ADDENDUM NO. 03

Project: **Jersey Village High School Renovations**
Cypress Fairbanks Independent School District

Issued by: Texas Arcadis, Inc.
P. O. Box 891209
Houston, TX 77289
281-286-6605

AREA G DEMO FOUNDATION PLAN
 SCALE: 1/8" = 1'-0"

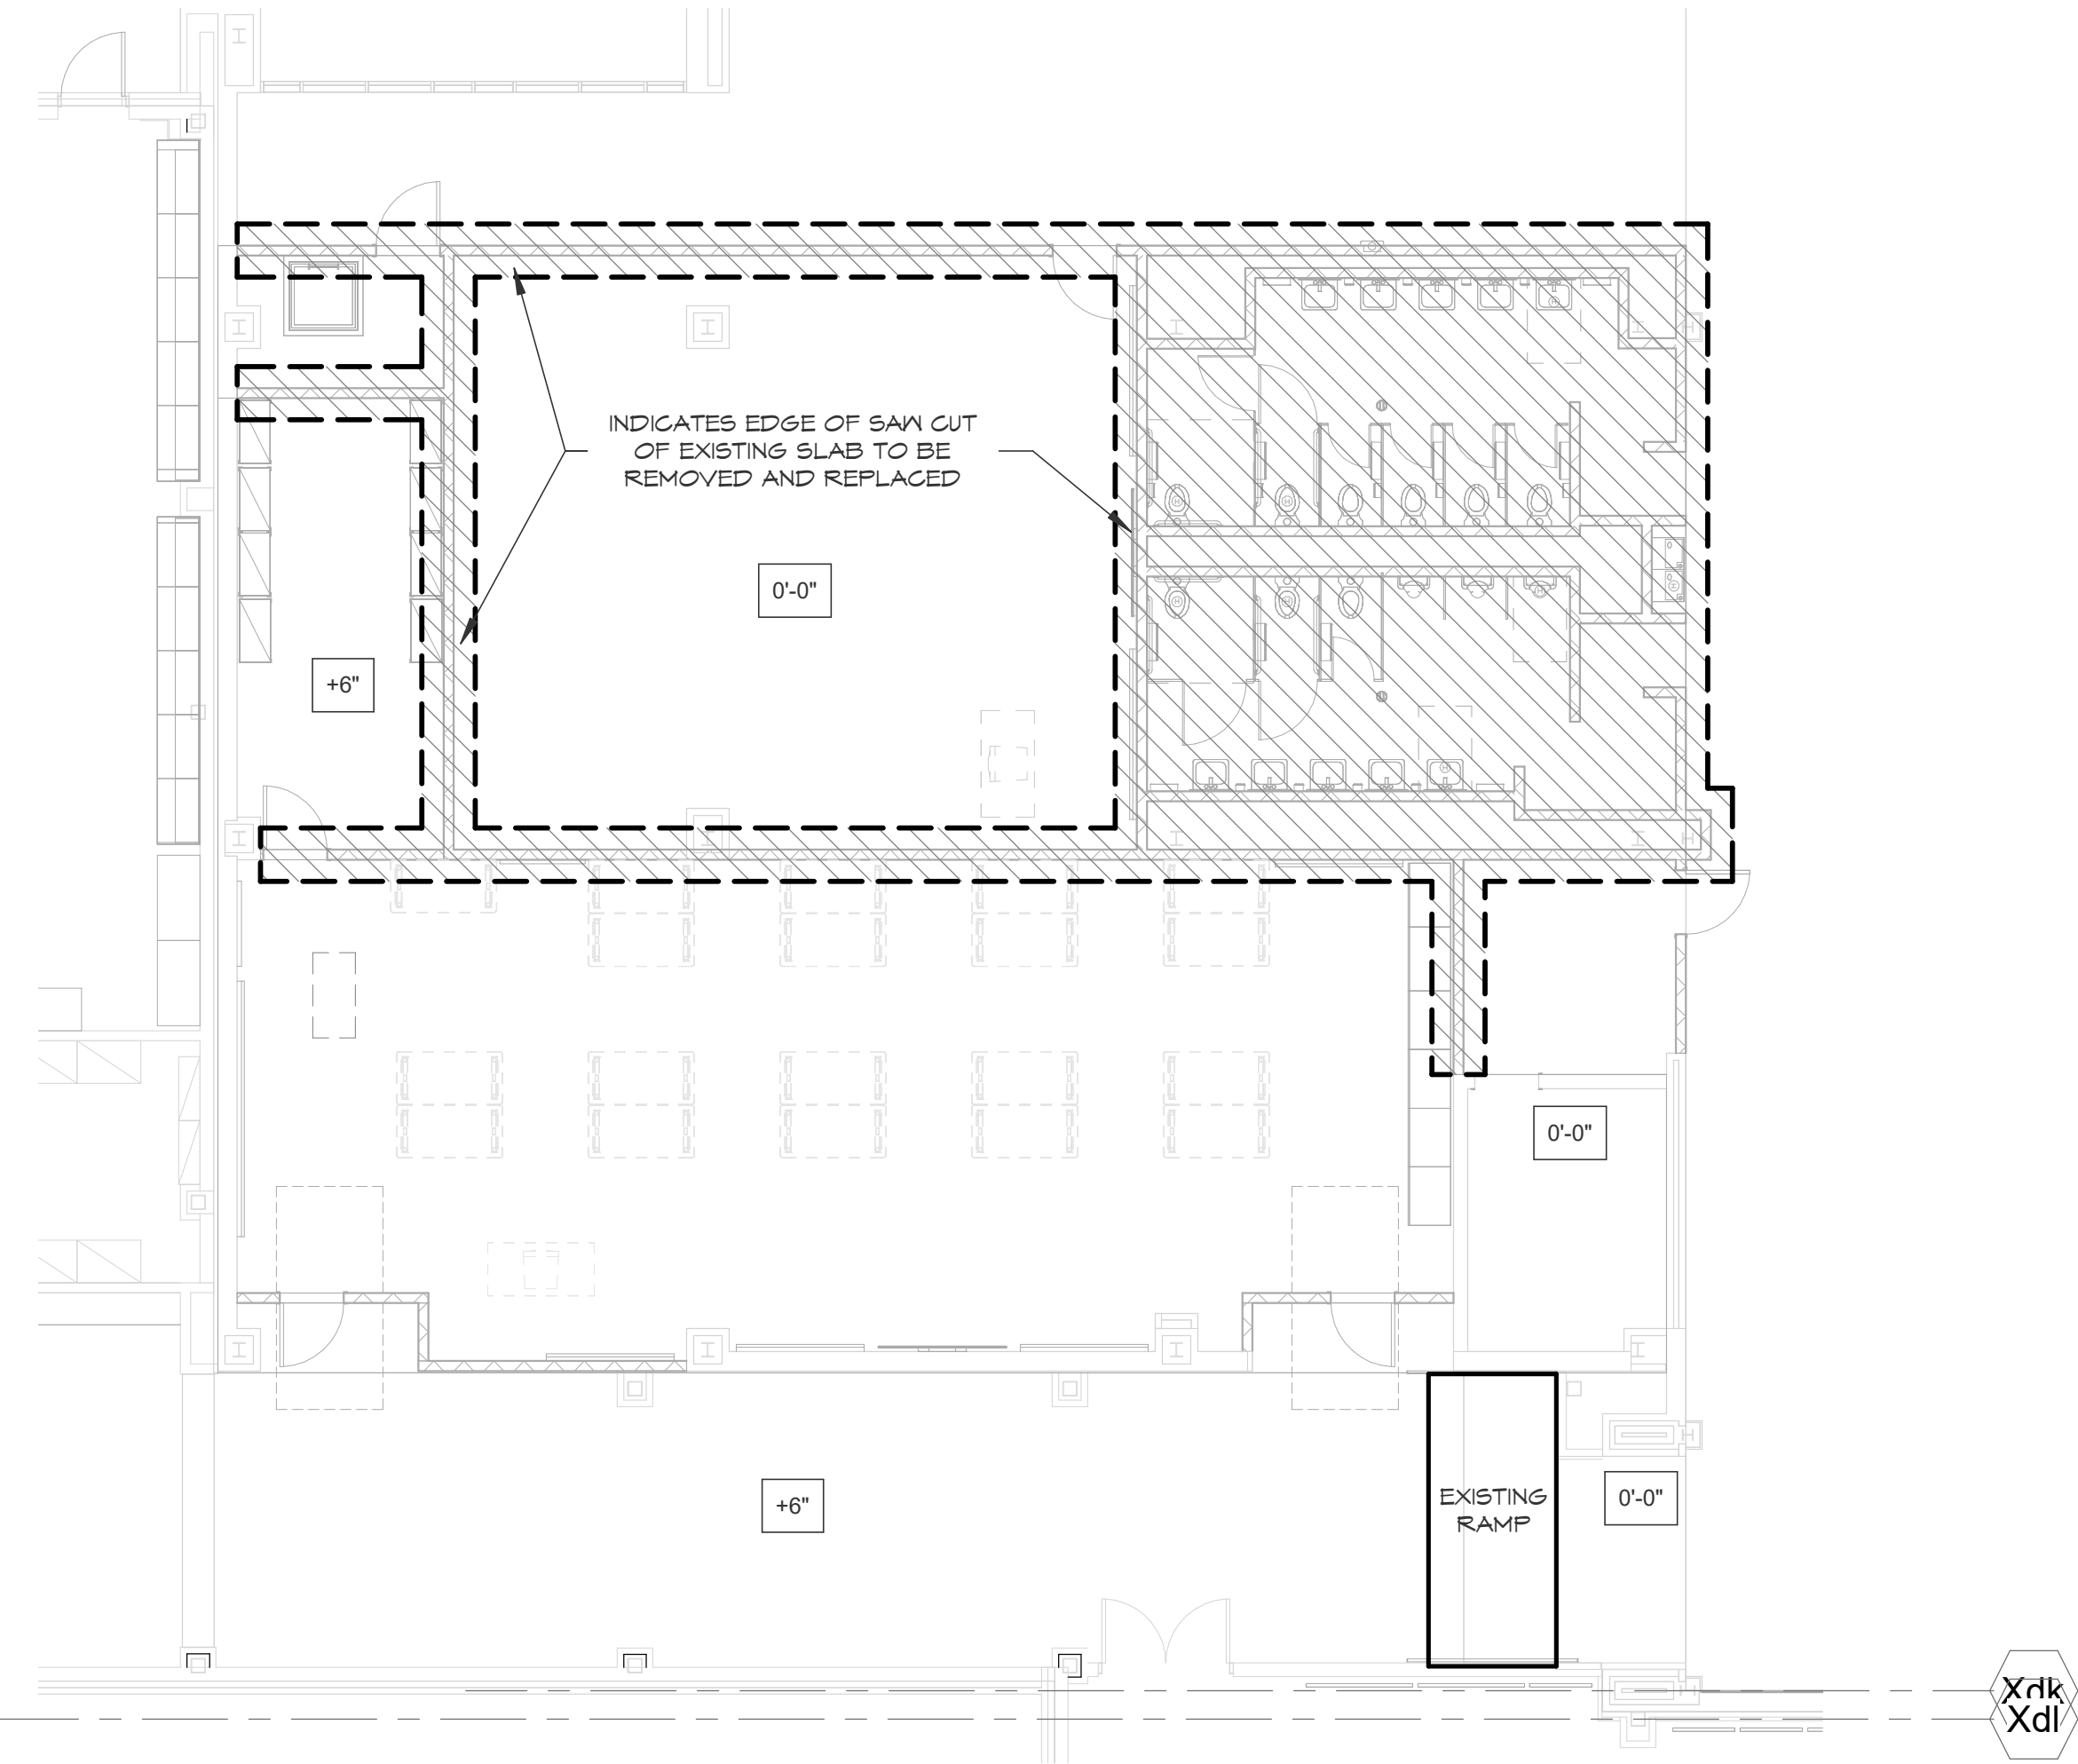
7. Sheet SD1.02 – Area G, H, M, & R Demo Foundation Plan
a. Add demo plan for area G new AV slab
8. Sheet S1.01 – Area G, H, P, & Q Foundation Plan
a. Update depressed slab extents in area P foundation plan to match architectural and food service

**AREA P
FOUNDATION PLAN**
SCALE: 1/8" = 1'-0"

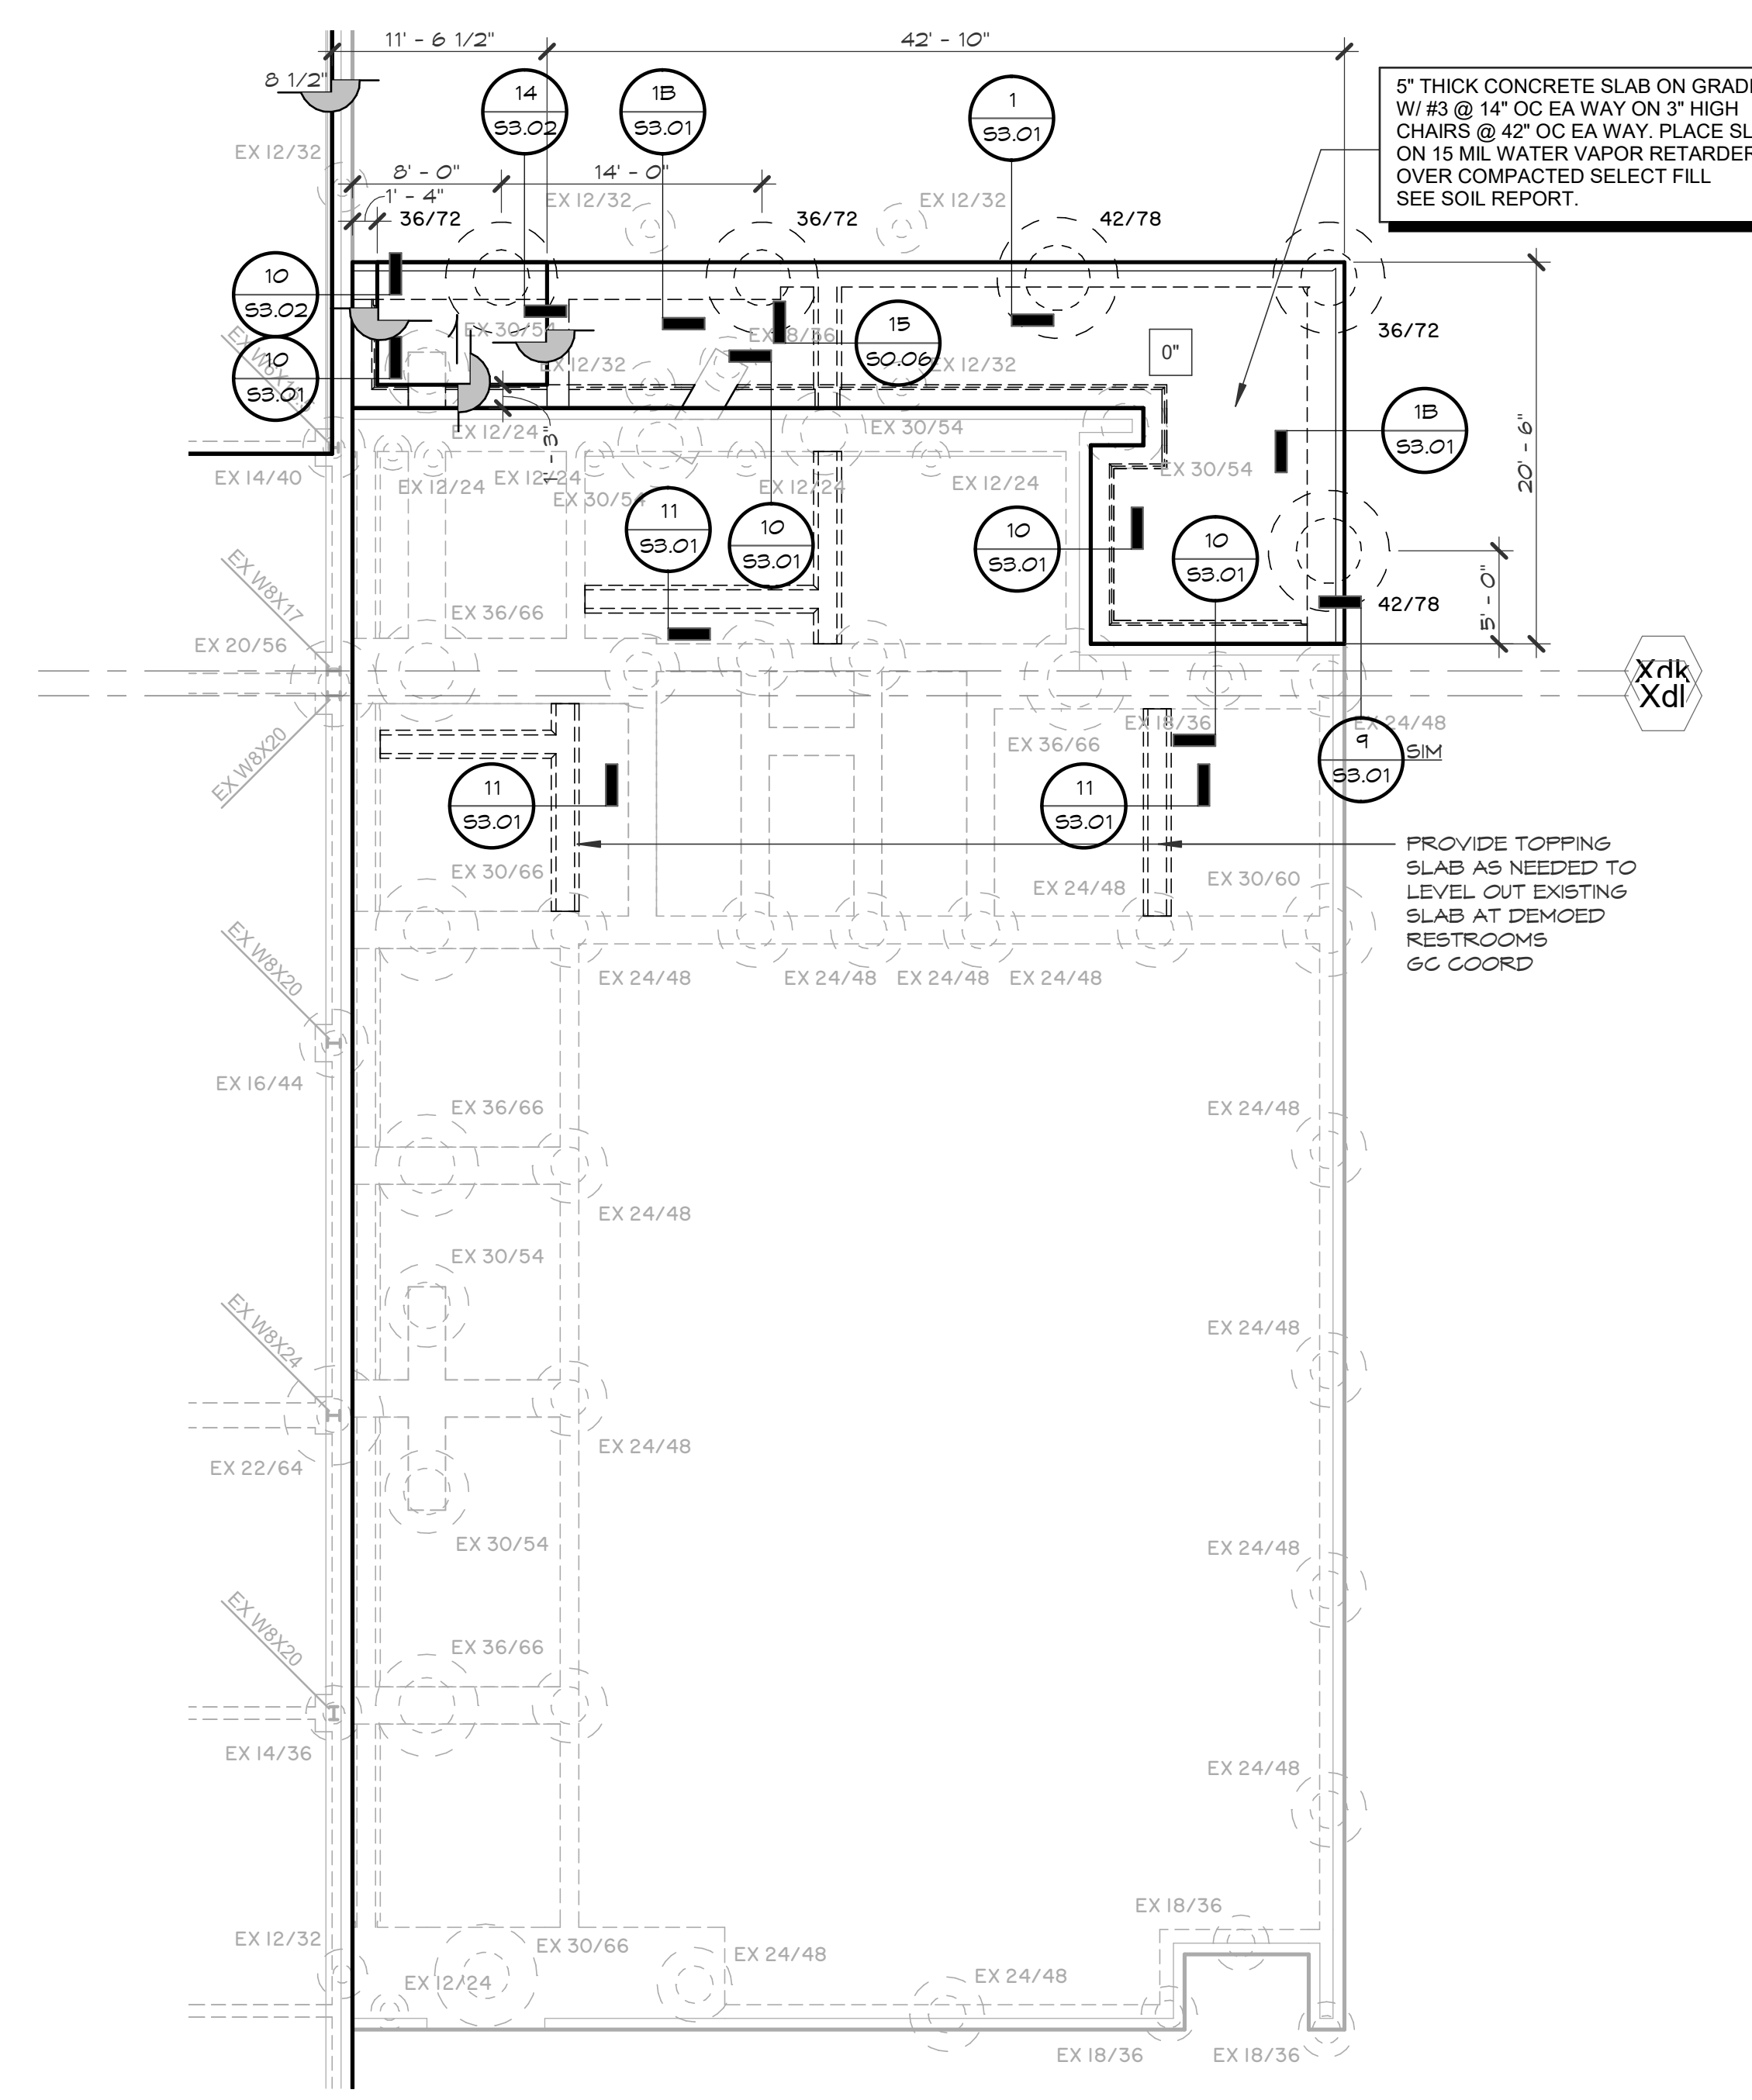
b. Add note by area P foundation plan that reads “GC COORD DROPPED SLAB LOCATIONS WITH ARCH AND FOOD SERVICE”
9. Sheet S3.02 – Foundation Details
a. Detail 13 – Change depth of 6” closure wall to 1’-0” below the exterior grade

20 DETAIL AT NEW AV
SCALE: 3/4" = 1'-0"

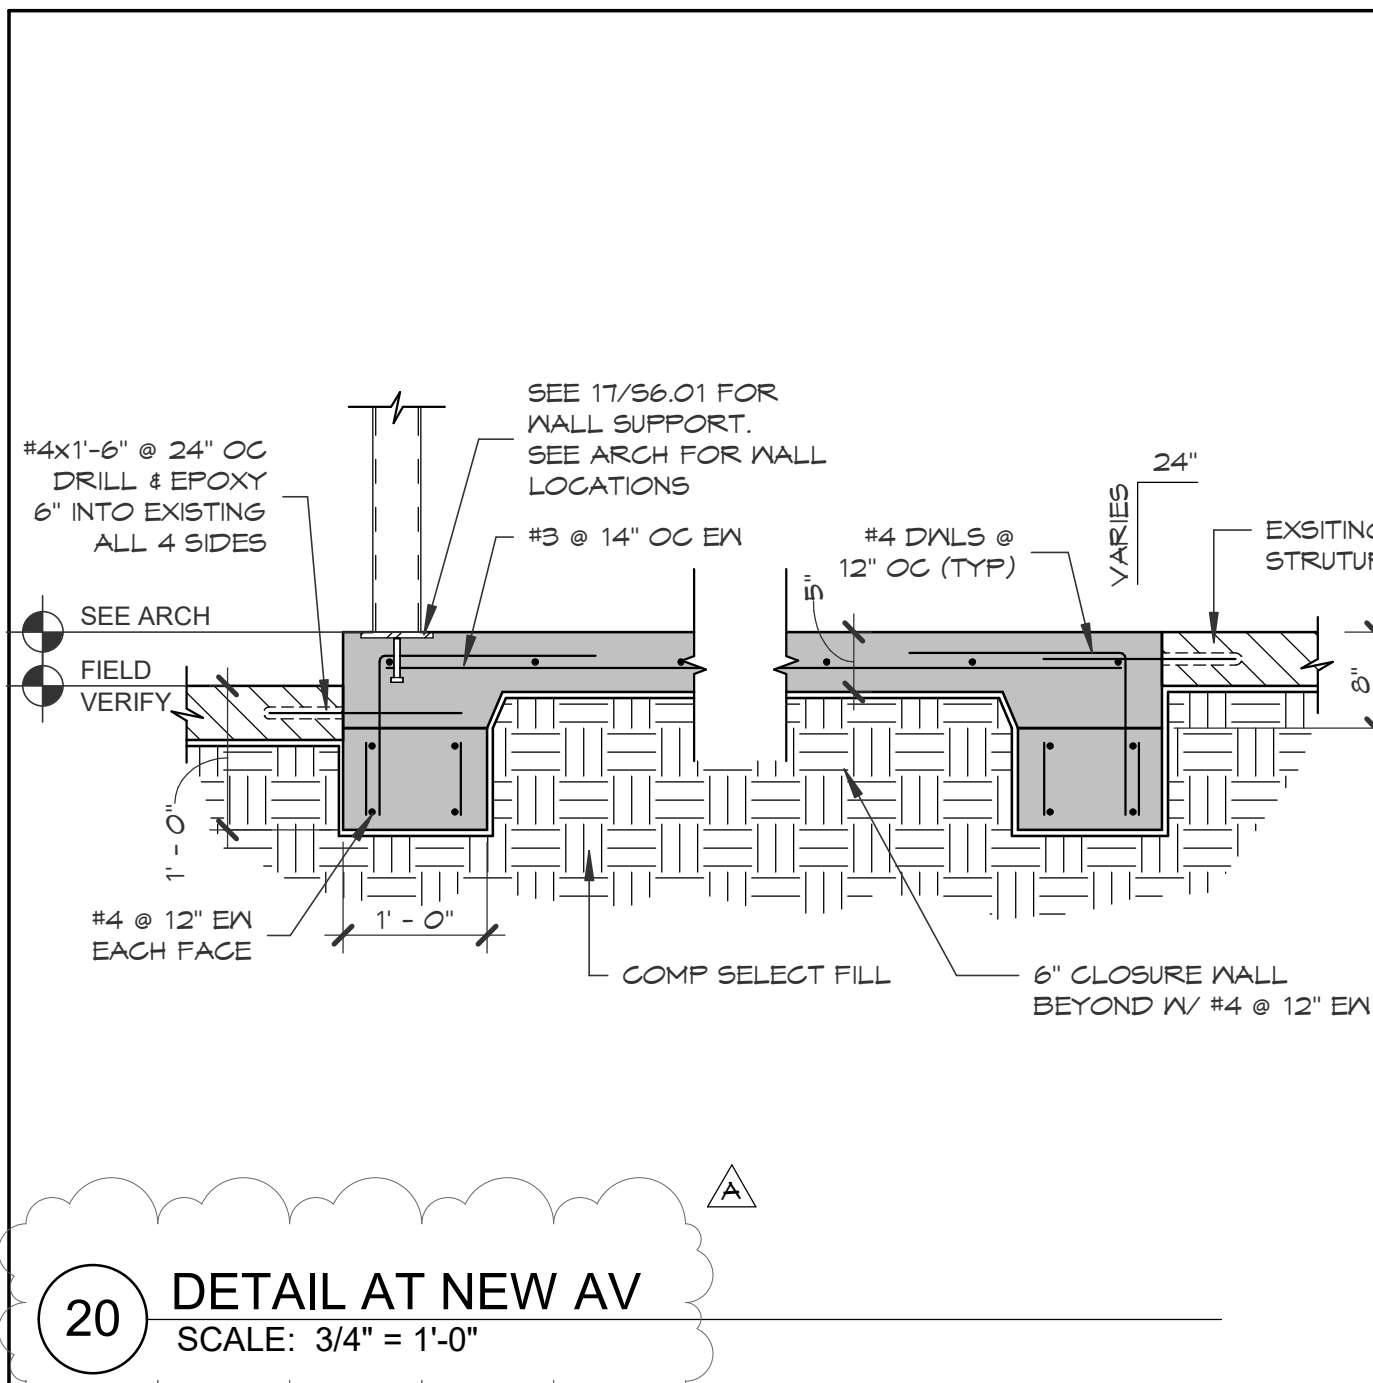
b. Detail 20 – Change detail to match architectural drawings to show a new flat AV slab poured in the demoed area of the existing slab with dowels drilled and epoxied into the existing slab on all four sides
